Technical Service BULLETIN

DOOR CHECK POPPING NOISE

'04 – '06 Sienna

REVISED
NV003-07
NVH

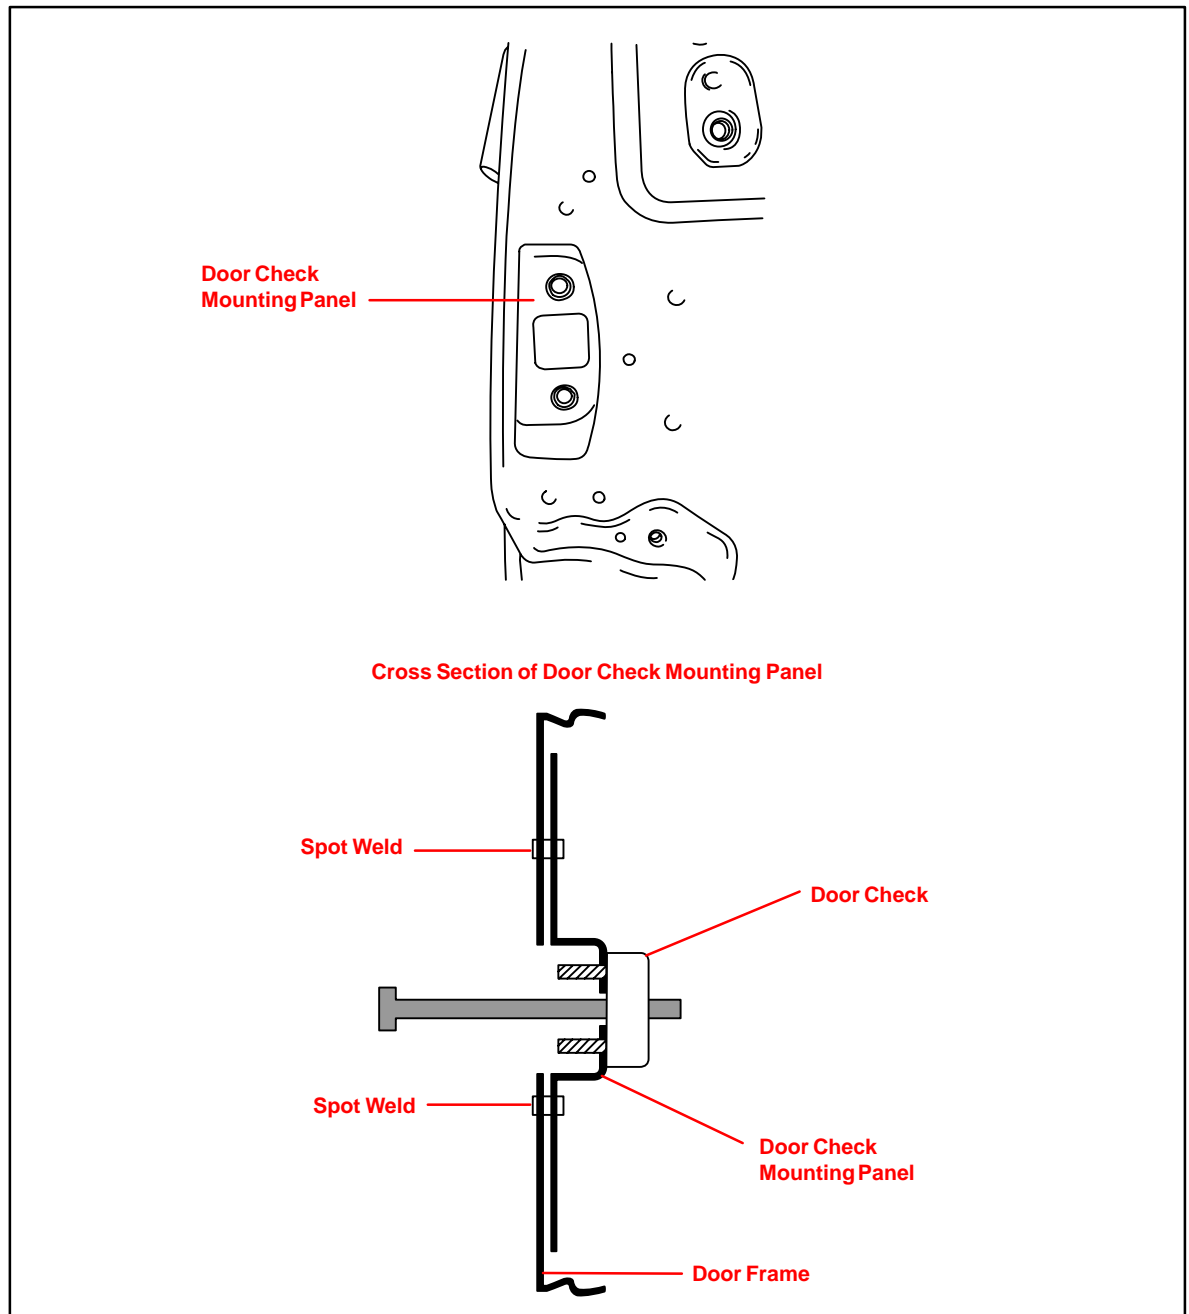
Inspect the door frame around the door check mounting area.

- If a spot weld or check mount area is cracked or split, the following repair method **CANNOT** be performed and the door assembly **MUST** be replaced.

- If a door is to be replaced, *all hemming flanges and body panel seams MUST* be sealed with body seam sealer prior to painting the door assembly.
